REPORT CORRECTED BY STAFF 6-4-93
REPORT AMENDED BY CPC 5-27-93
REPORT AMENDED BY STAFF 5-26-93
CITY PLANNING COMMISSION

APPLICANT: <u>Hallenbeck, Chamorro & Associates, 2415 Mariner Square Dr., Alameda, CA 94501</u>
OWNER: <u>United Services Automobile Association, USAA Building, San Antonio, Texas 78288</u>
PLANS BY: <u>Hallenbeck, Chamorro & Associates, 2415 Mariner Square Dr., Alameda, CA 94501</u>
FILING DATE: <u>November 24, 1992</u> ENVIR DET: <u>Neg. Dec</u> REPORT BY: <u>Doug Holmen</u>
ASSESSOR'S PCL. NO. <u>277-0151-15, 26</u>

- APPLICATION:
- A. *Negative Declaration (Added by staff)*
 - ~~A.B.~~ Mitigation Monitoring Plan
 - ~~B.C.~~ Special Permit Modification to construct a total of 702,394 \pm square feet of office, including an existing 288,611 \pm square feet of office on 23.05 \pm partially developed acres in the Office Building (Planned Unit Development) (OB(PUD)) and Light Industrial (M-1) zones.
 - ~~C.D.~~ PUD Schematic Plan Amendment to rearrange the construction of pre-approved 413,833 \pm square feet of office and related uses in the OB(PUD) and M-1 zones.

LOCATION: Northwest corner of Arden Way and Harvard Street (2241 Harvard Street).

SCHEMATIC SITE PLAN

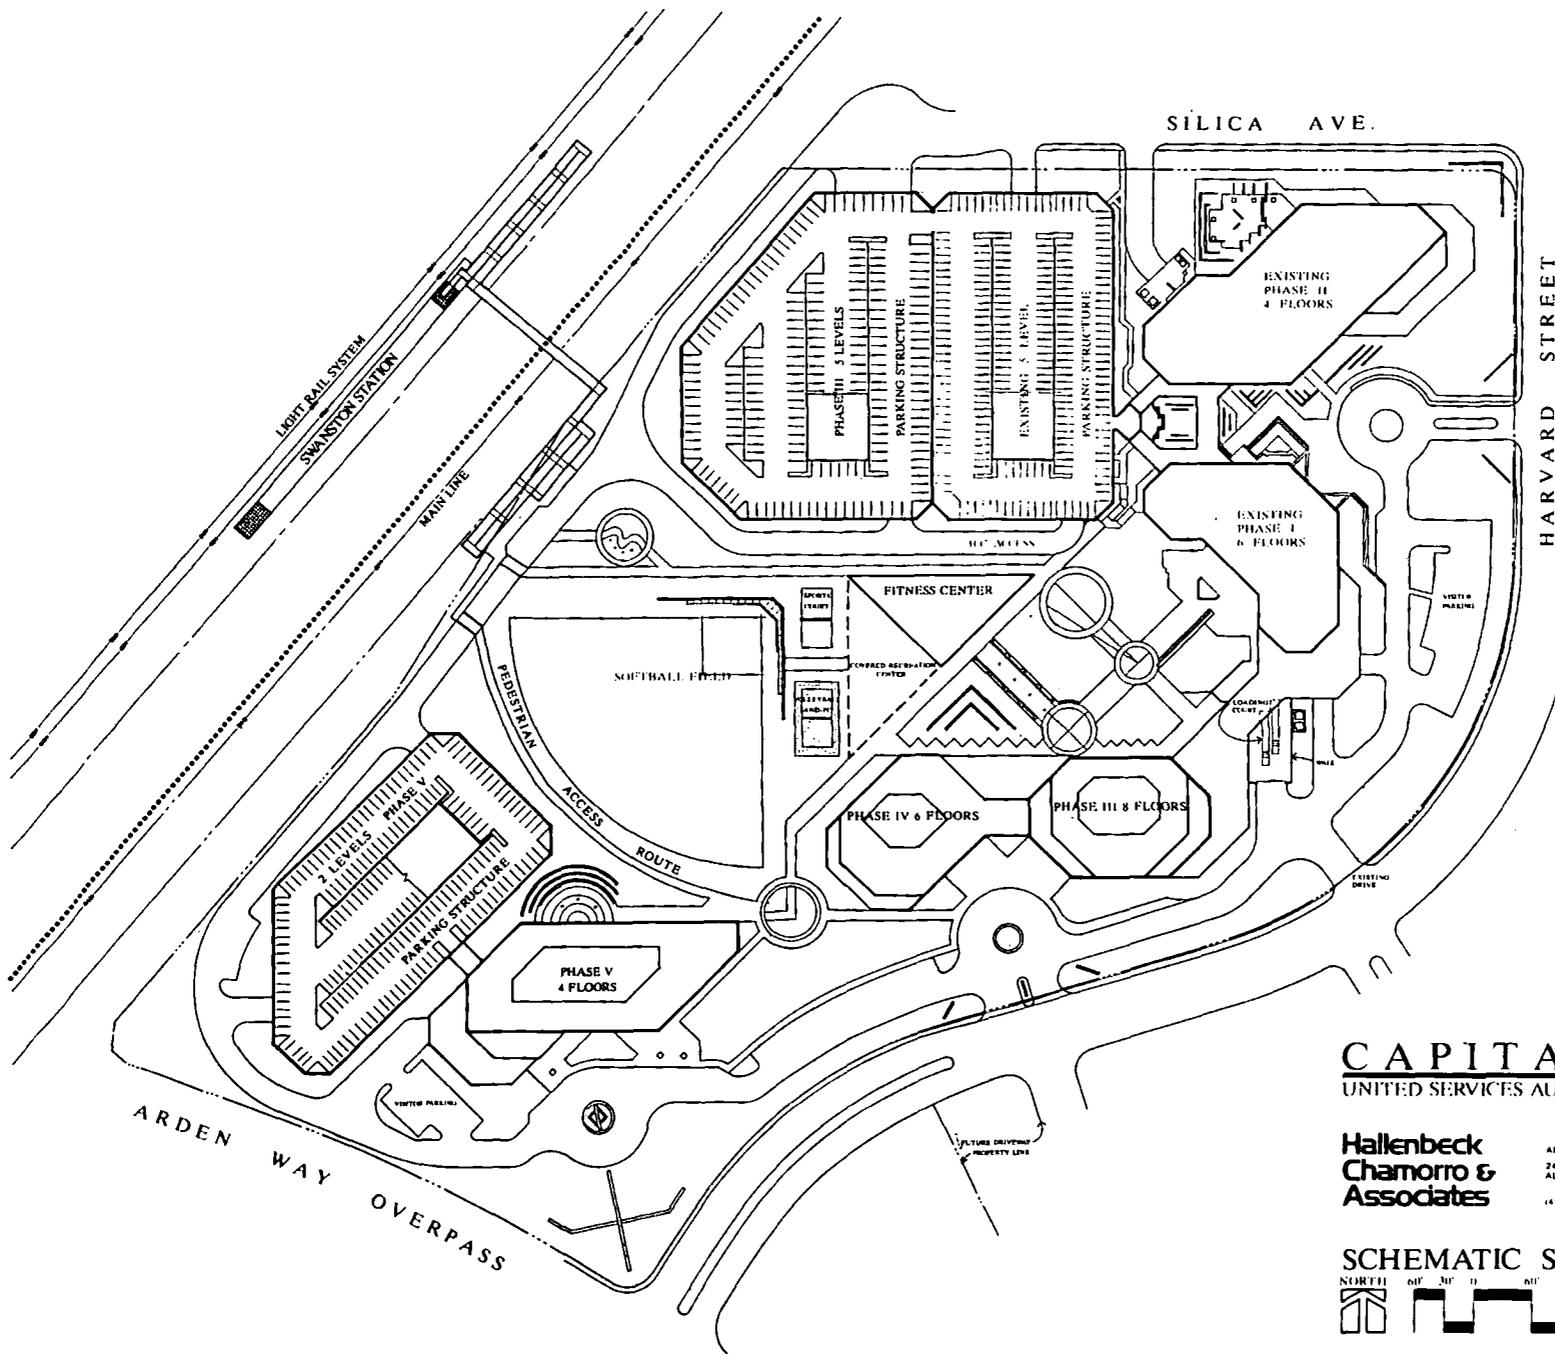
The site plan (Exhibit A) indicates that there would be a total of 2,600 parking spaces associated with the proposed project. The applicant, however, has indicated in a letter dated March 3, 1993 that the total number

1. *Provide a pedestrian walkway from Phase V building to the Arden Way/Harvard Street intersection.*
2. *All parking spaces shall be designed to City standards.*
3. *Driveway adjacent to the "loading court" shall be aligned with the access to property across Harvard Street or off-set 120'.*
4. *Signs adjacent to driveways shall be 10' (minimum) from street right-of-way and 10' (minimum) from driveway. Signs in driveway island is not recommended.*
5. *Location of Phase V parking structure will necessitate the need for speed control devices in access drives. Redesign is recommended.*

6. *All driveways shall be built to City standards. Driveways that are to be used by large delivery vehicles may be designed to standards for industrial driveways*
7. *Islands in driveways must be behind right-of-way line.*
8. *Access to site must be approved by Fire Department and the Solid Waste Division of Public Works.*
9. *Phase IV parking is not shown.*
10. *Main entrance on Harvard Street requires a minimum of 100' of stacking for Phase V parking. If Phase III and/or IV parking will use this entrance, additional stacking may be required.*
11. *Reconstruction of median in Harvard Street may be required to provide adequate left-turn stacking.*

13. *Phase IV parking is not shown. (Added by staff)*
14. *Main entrance on Harvard Street requires a minimum of 100' of stacking for Phase V parking. If Phase III and/or IV parking will use this entrance, additional stacking may be required. (Added by staff)*

of parking spaces would not exceed 2,453 as originally indicated in the previously approved projects (P84-101, P85-018, P87-109). There are currently 1,055 parking spaces in the existing five level parking structure off of Silica Avenue. The applicant proposes to construct a 5 level parking structure adjacent to the existing parking structure which would contain 649 spaces for Phase III and an additional 494 spaces in Phase IV for a total of 1,143 spaces. Phase V would contain a two level parking structure at the southwest corner of the site which would contain 402 spaces. Currently, there is visitor parking off of Harvard Street adjacent to the existing most southerly building. The applicant proposes to construct an additional 20 visitor parking spaces adjacent to the Phase V building when Phase V is built (see parking table on Exhibit A). The additional 147 spaces (2,600 minus 2,453) would need to be removed from one of, or in combination of the Phase III, IV and V projects.

7. *Driveway adjacent to the "loading court" shall be aligned with the access to property across Harvard Street or off-set 120'. (Added by staff) *to the satisfaction of the Transportation Division (Amended by CPC)*

9. *Location of Phase V parking structure will necessitate the need for speed control devices in access drives. Redesign is recommended. (Added by staff)*

13. *Phase IV parking is not shown. (Added by staff)*
14. *Main entrance on Harvard Street requires a minimum of 100' of stacking for Phase V parking. If Phase III and/or IV parking will use this entrance, additional stacking may be required. (Added by staff)*
